APPLICATION FOR A CERTIFICATE OF APPROPRIATENESS – STAFF REPORT

026-18-CA 807 MCCULLOCH STREET
Applicant: KENT KILPATRICK
Received: 02-08-2018 Meeting Date(s):
Submission date + 90 days: 05/09/2018 1) 04/26/2018

Nature of Project: Construct reconfigured rear addition with second story and wraparound porch; remove/replace/add windows; remove second door on front elevation; change exterior paint colors

① ELEVATION - NORTH - RENOVATION
3/16" = 1'-0"

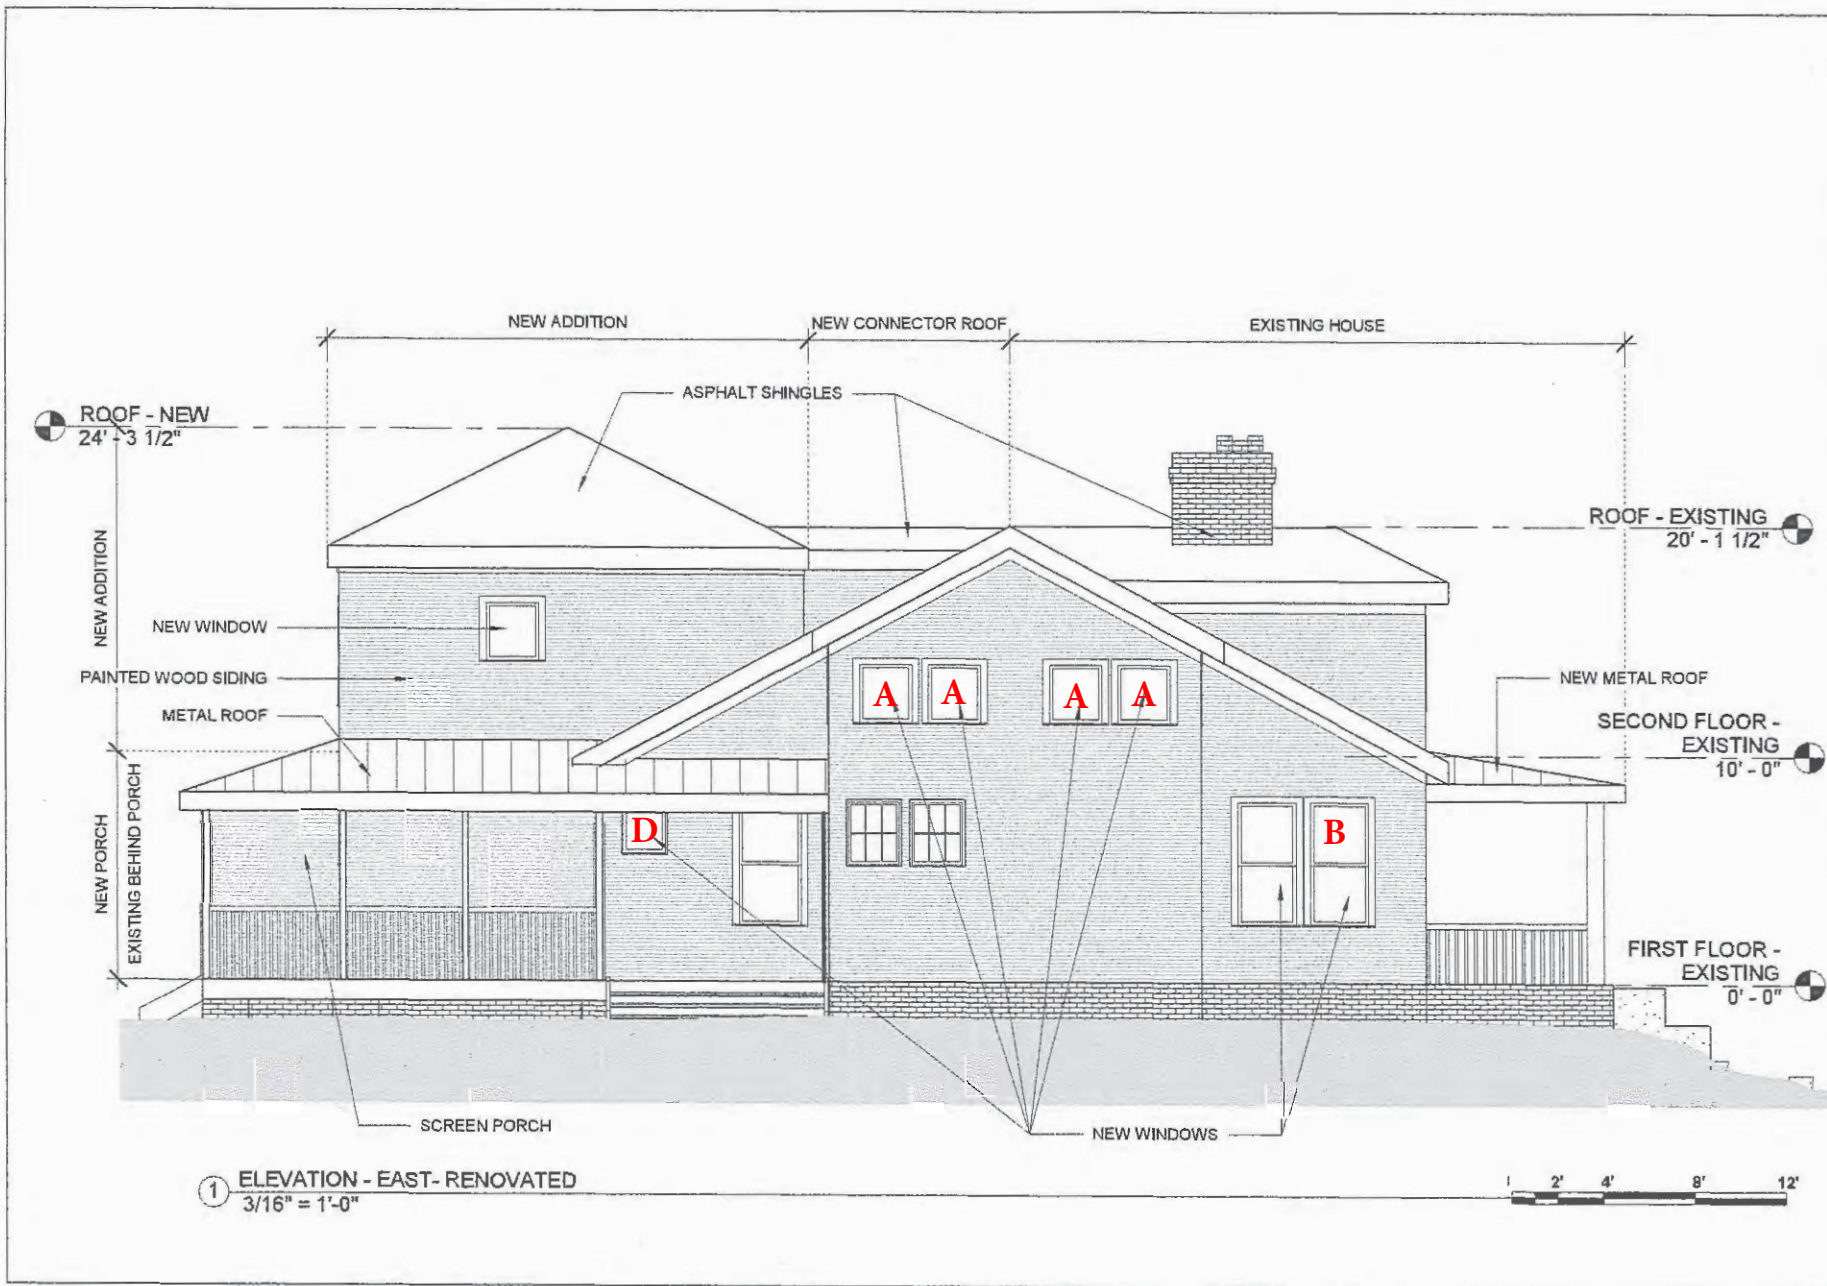
- 1* The existing door proposed for removal on the front elevation is proposed to be replaced with an additional window to create a balanced entrance (window will be added directly next to the existing window). Structural evidence included in the application indicates that the door was added at an unspecified date and is not original to the design of the house.
- 2* The application includes an example of a similar door-window configuration at 1026 Dorothea Drive.
- 3* Door details and specifications were not provided.

Tree Protection

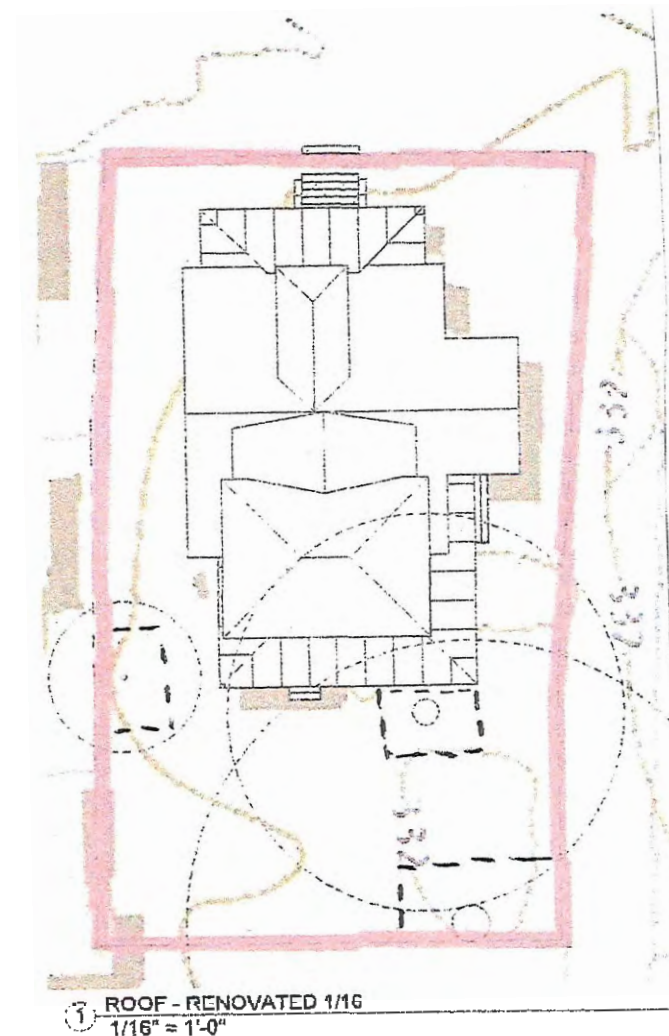
13* A tree protection plan was provided; however, the critical root zones may not be sufficiently protected with the plan. The critical root zone is defined as “The area uniformly encompassed by a circle with a radius equal to one and one-quarter (1.25) foot per inch of the diameter of a tree trunk measured at four and one-half (4.5) feet above the ground, with the trunk of the tree at the center of the circle.” The footprint of the proposed addition is within the critical root zone of at least one tree. The tree protection plan was not prepared by an arborist or landscaped architect.

14* Staging areas for construction materials were not specified on the tree protection plan.

1. That the metal roof have a flat pan.
2. That tree protection plans be implemented and remain in place for the duration of construction.
3. That details and specifications for the following be provided to and approved by staff prior to issuance of the blue placard:
 - a. A tree protection plan that addresses the critical root zones and provides staging areas for construction materials.
 - b. That the tree protection plan for at least the tree closest to the house be prepared by an arborist certified by the International Society Arboriculture.
4. That details and specifications for the following be provided to and approved by staff prior to installation or construction:
 - a. doors
